STATE OF MAINE
DEPARTMENT OF TRANSPORTATION
16 STATE HOUSE STATION
AUGUSTA, MAINE
04333-0016

January 18, 2007
Subject: **Topsham**
Pin No. 14062.11
Amendment No. 4

Topsham
14062.11
Highway Maintenance Garage
January 16, 2007

ENGINEERING		CONSULTING 1265 ALBION ROAD WINSLOW, MAINE 04901 (PH & FAX) 207-873-4928	
		PROJ. TOPSHAM HIGHWAY MAINTENANCE GARAGE TOPSHAM, MAINE	
TITLE CURB WALL SECTION			
DATE 05-19-06	SCALE AS SHOWN	JOB NO LP ENG 300-01-06	DRAWING NO A-1A
BY L. P. Pelletier	CHKD

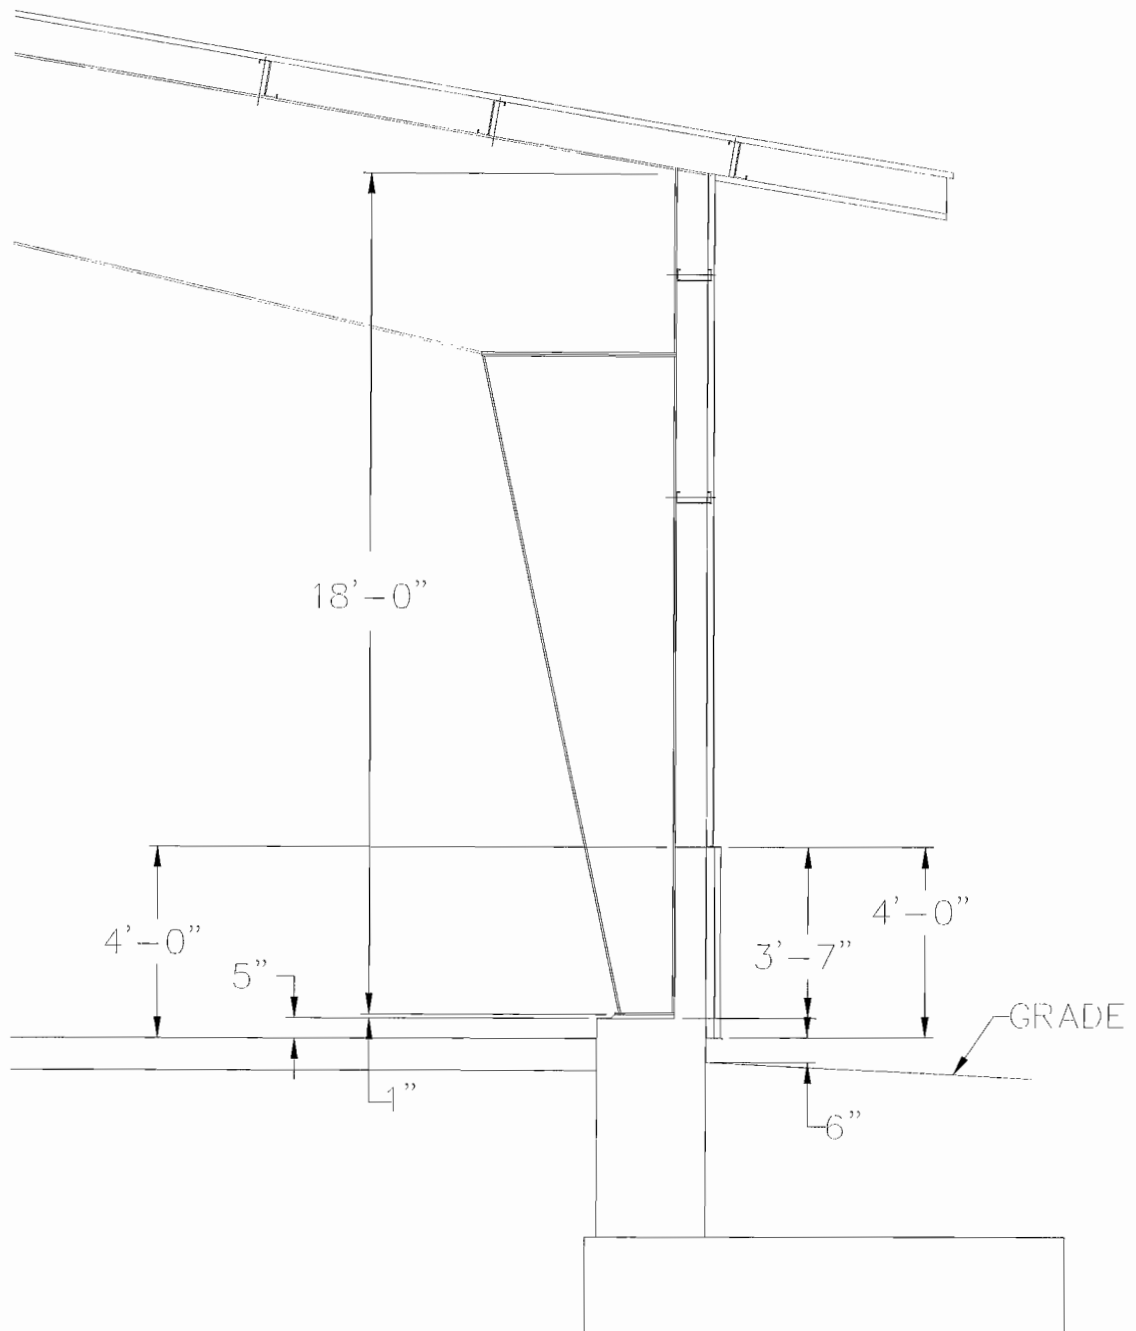
ADD to the plans the attached 8 1/2 X 11 detail drawings titled: “A-1A Curb Wall Section” and “A-1B Curb Wall Section”.

DATE 05-19-06	SCALE AS SHOWN	JOB NO LP ENG 300-01-06	DRAWING NO A-1D
BY L. P. Pelletier	CHKD CHKD

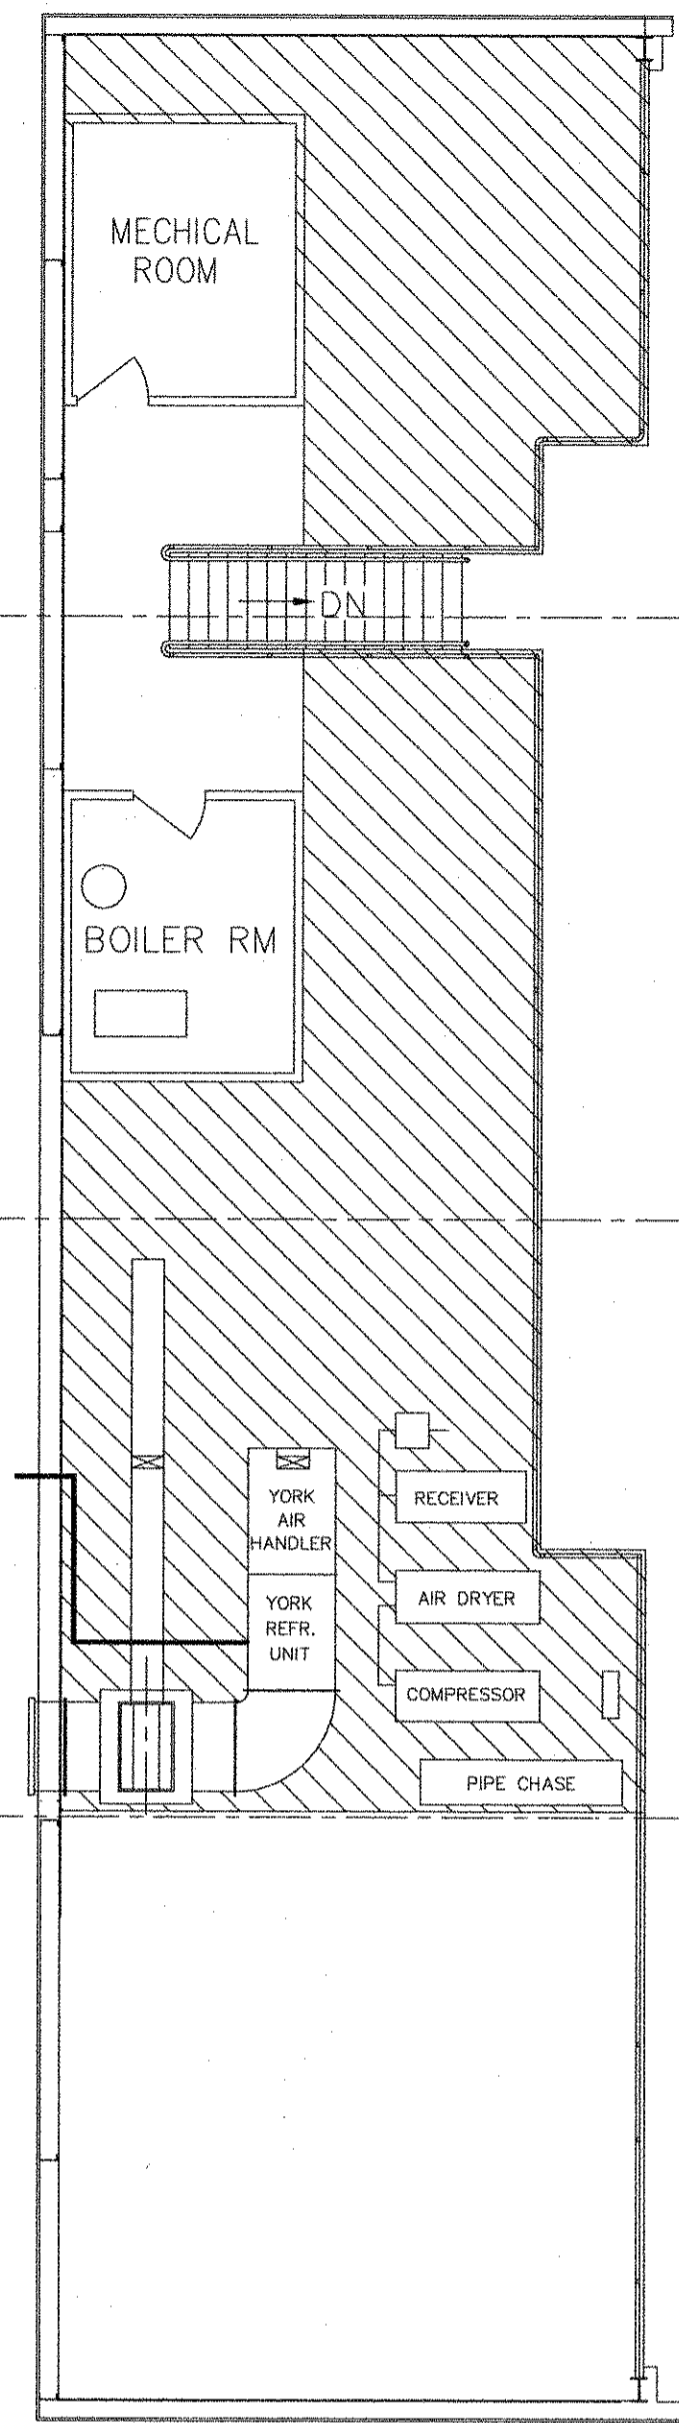
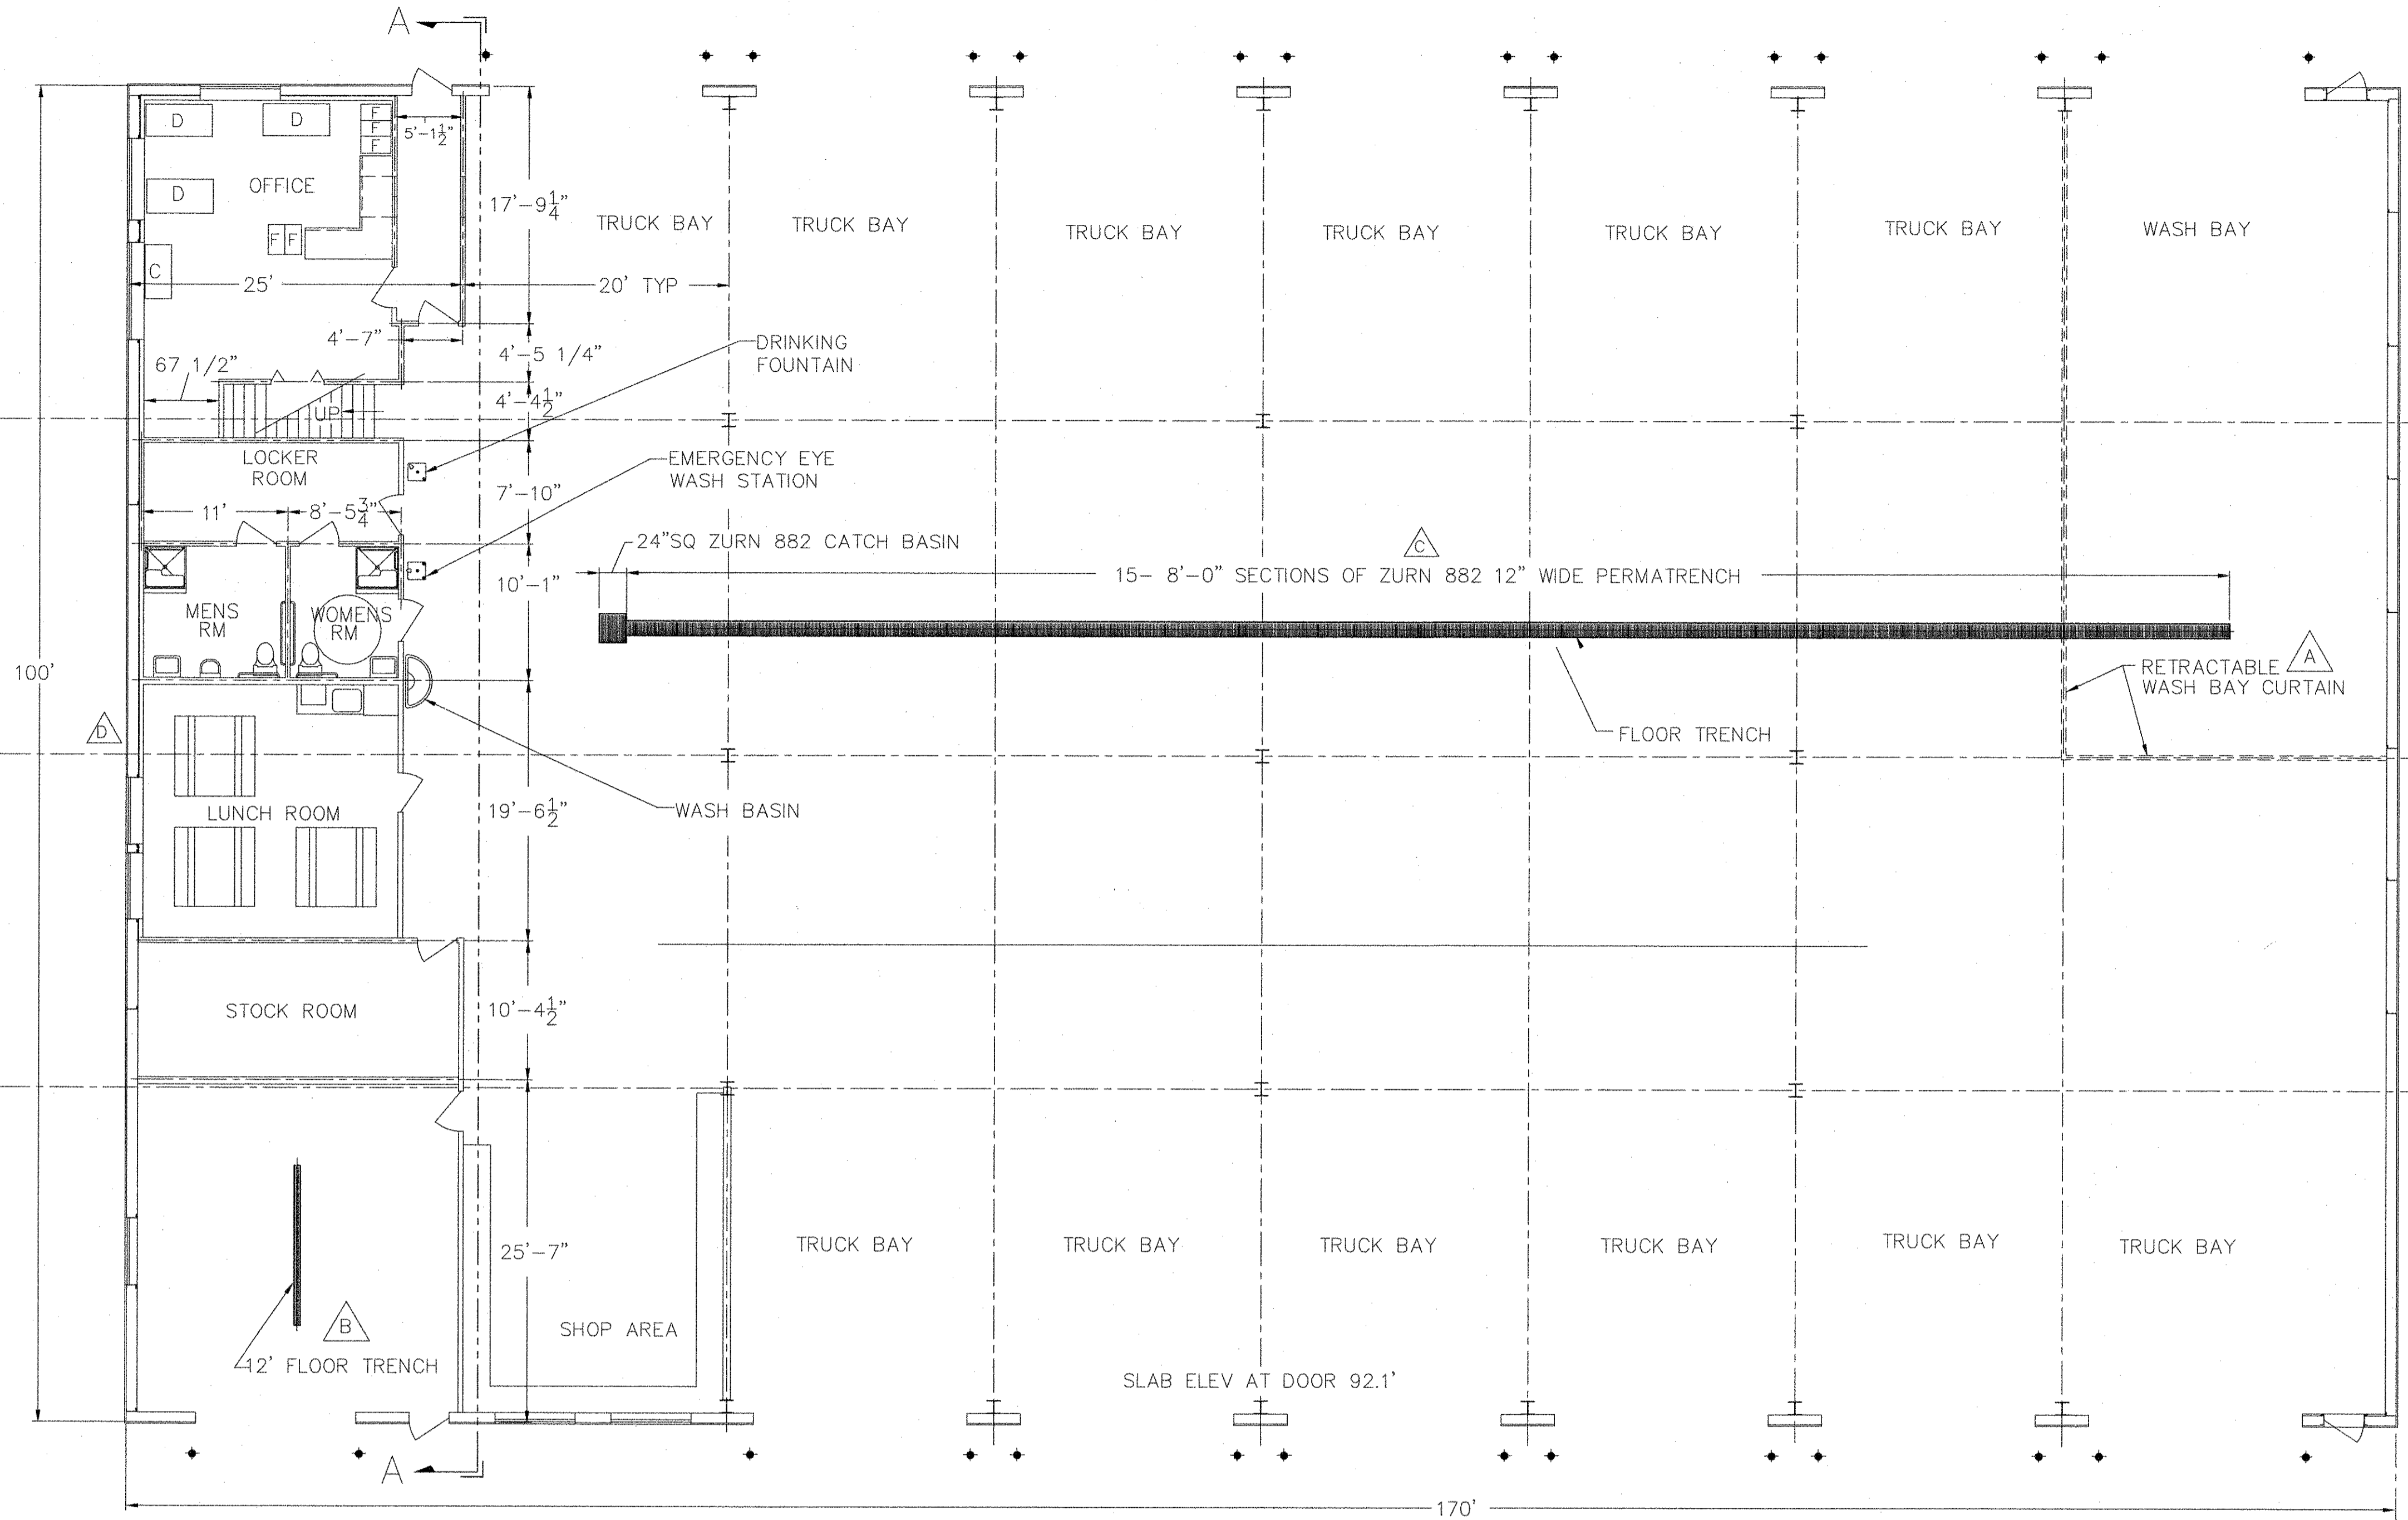
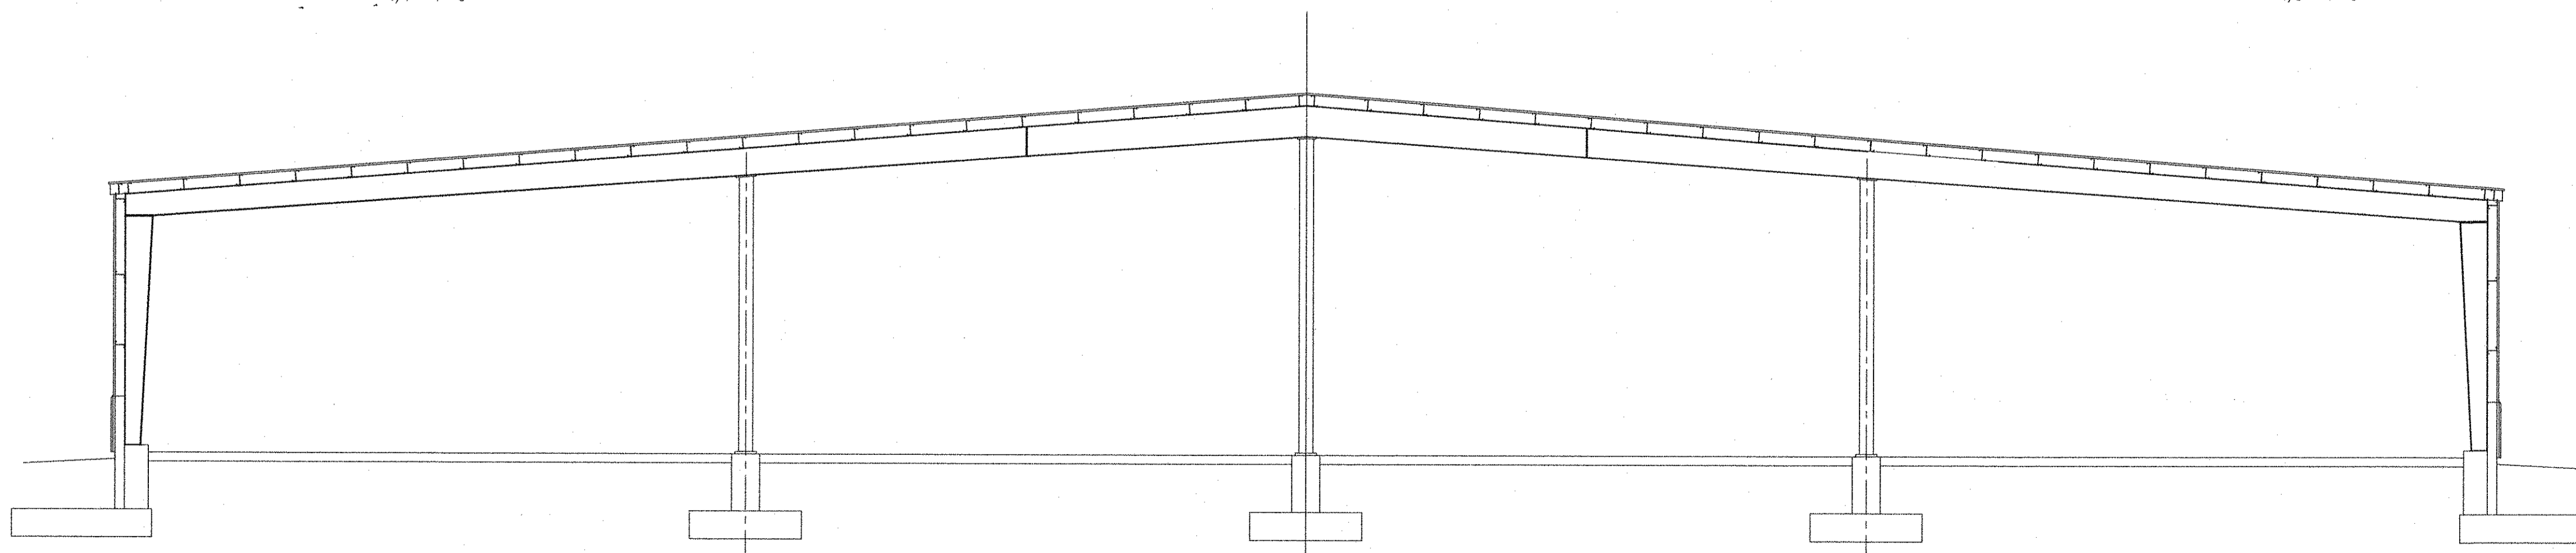
REMOVE the existing plan sheet A-1C “Building Plan” and replace with the new updated “A-1D, Building Plan”.

On plan sheets A-1D titled: “Building Plan” and P-3 titled: “1st and 2nd Floor Hot and Cold Water Piping Plan & Details” ADD an emergency eye wash station with a water heater, mixing valve and associated piping in the wash bay and ADD a wash fountain and associated piping in the shop area. Make these changes in pen and ink.
